ADDENDUM NO.2

IEB NO.V-1901 – UPS REPLACEMENT

August 15, 2019

ONE LINE DIAGRAM
NO SCALE

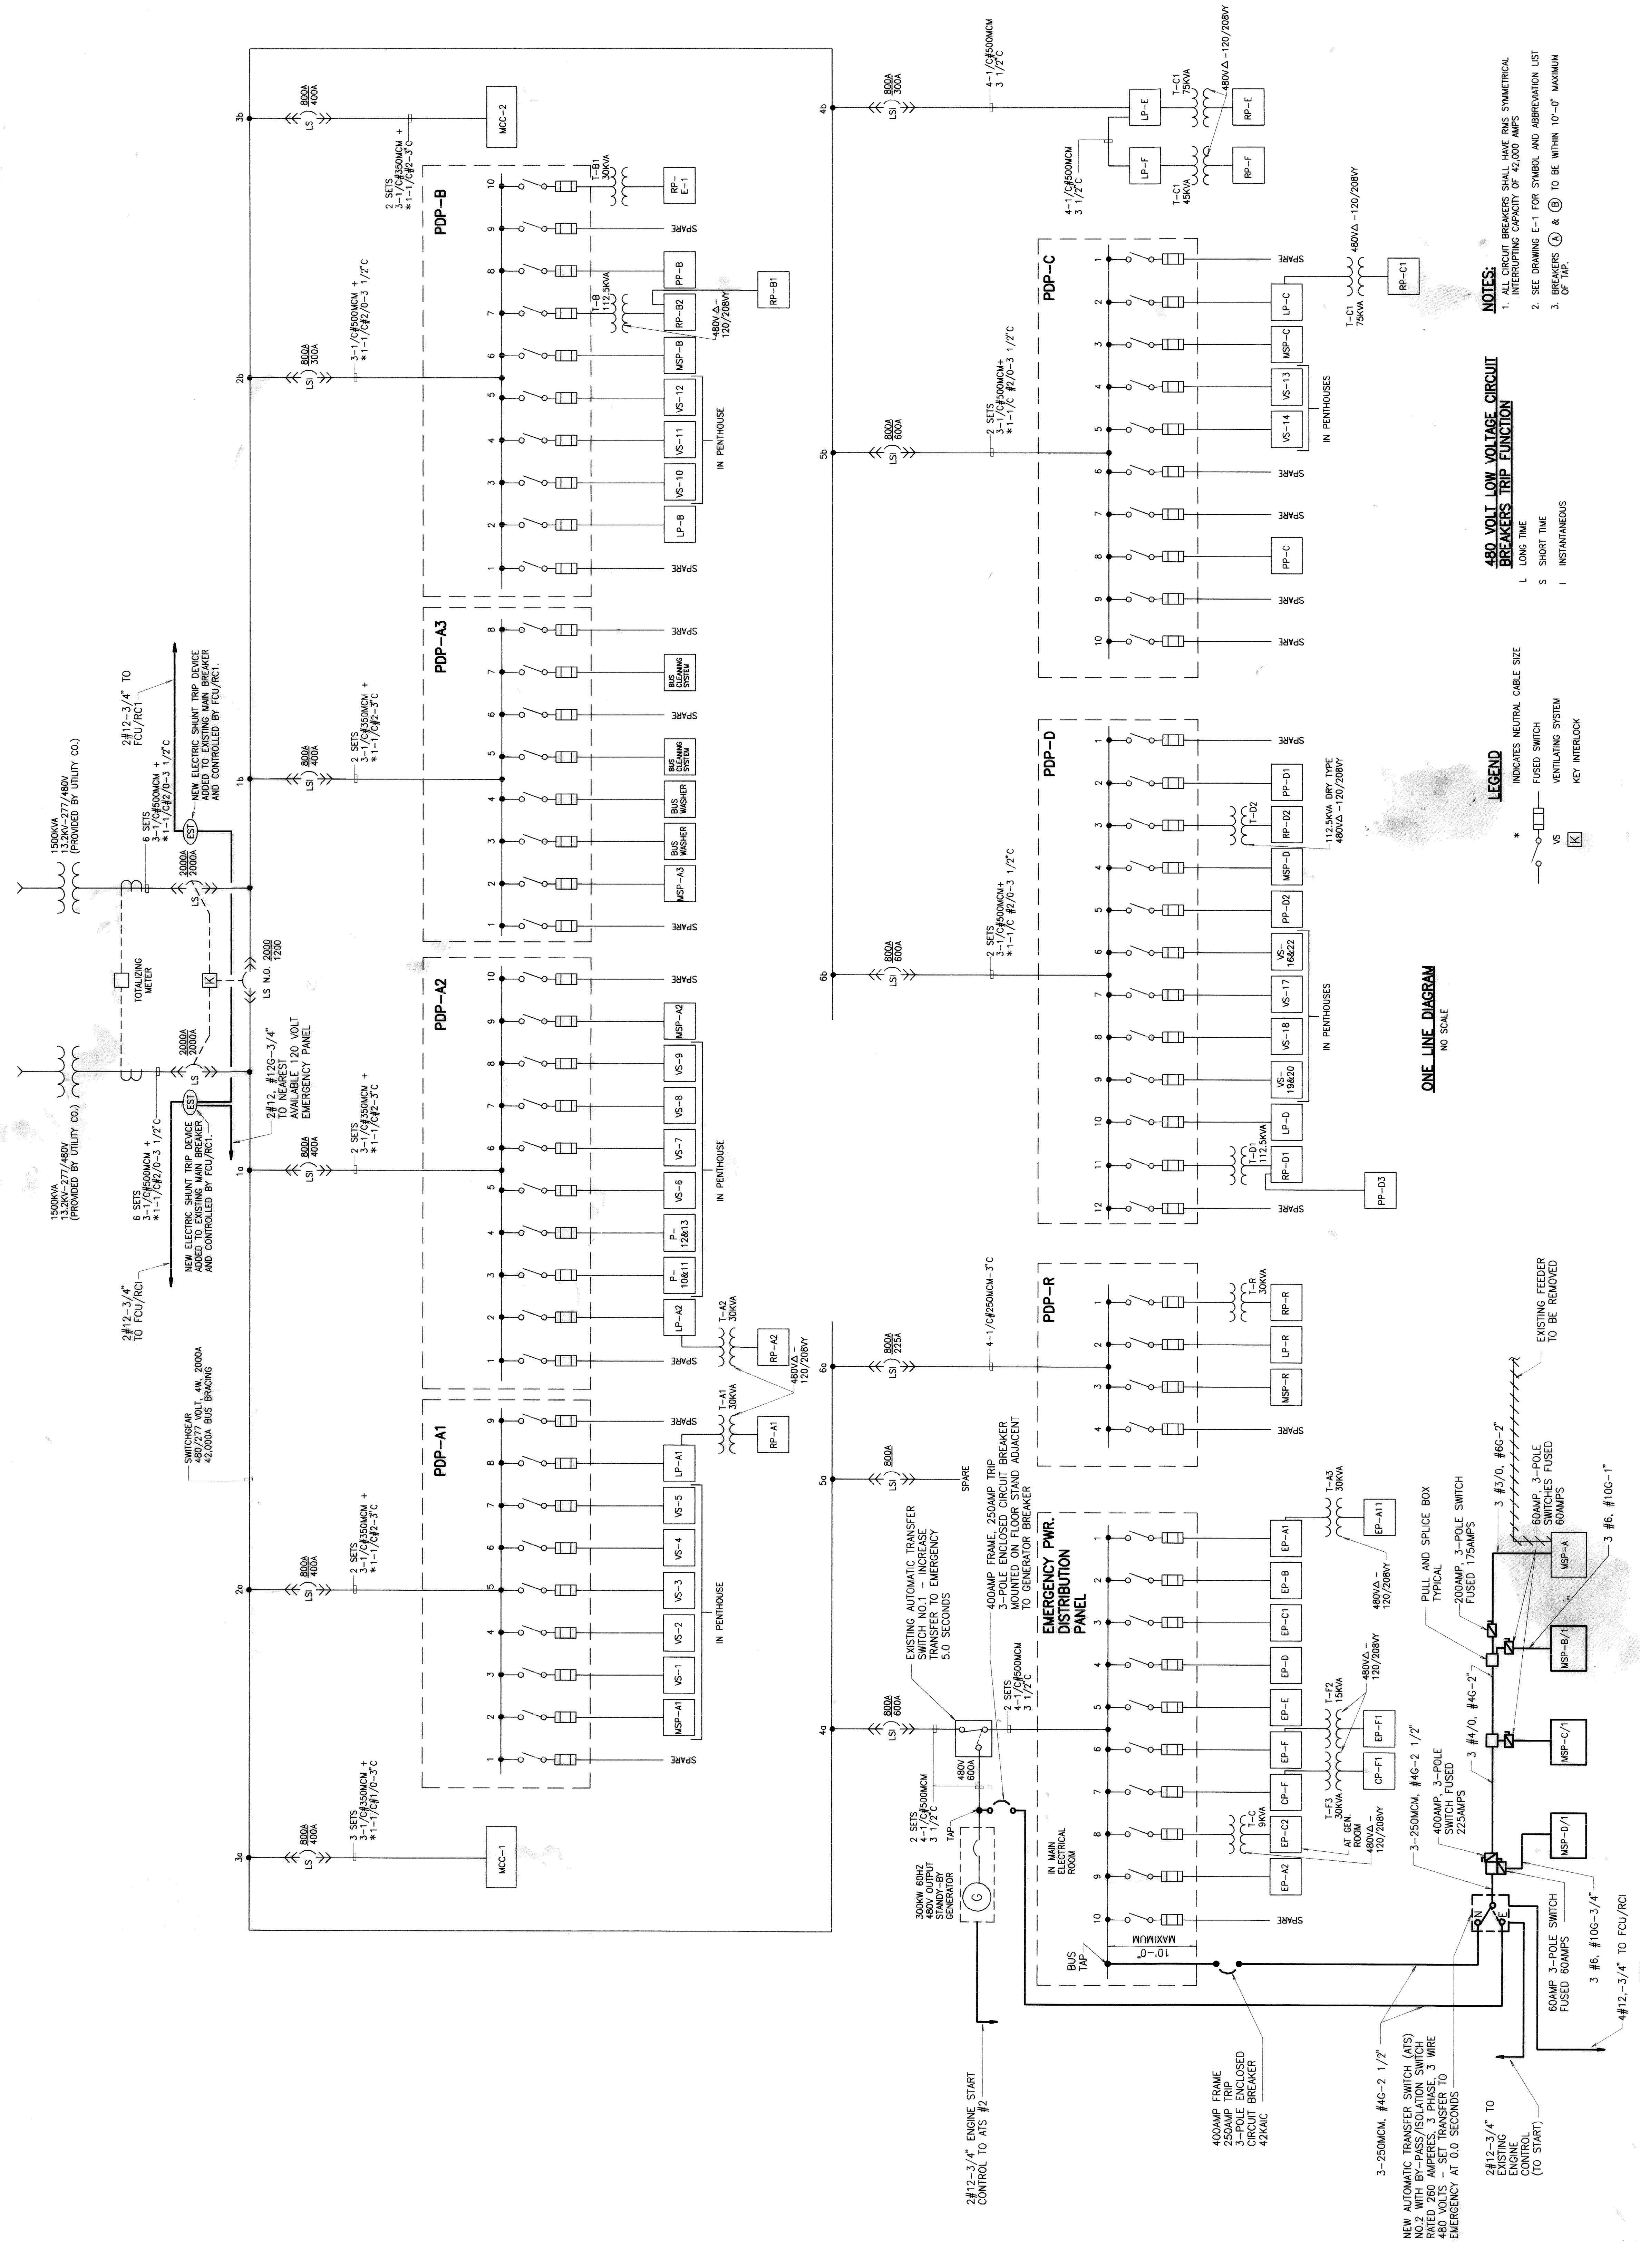
Notes added to the drawing attached:

- Second floor Panel EP-F (Original Panel) feeds a newer panel in the second floor closet (Transformer) to the EP-F1 panel. The UPS is labeled and feed out of EP-F panel.
- New electrical wire for the new UPS shall be for 60 Kva.
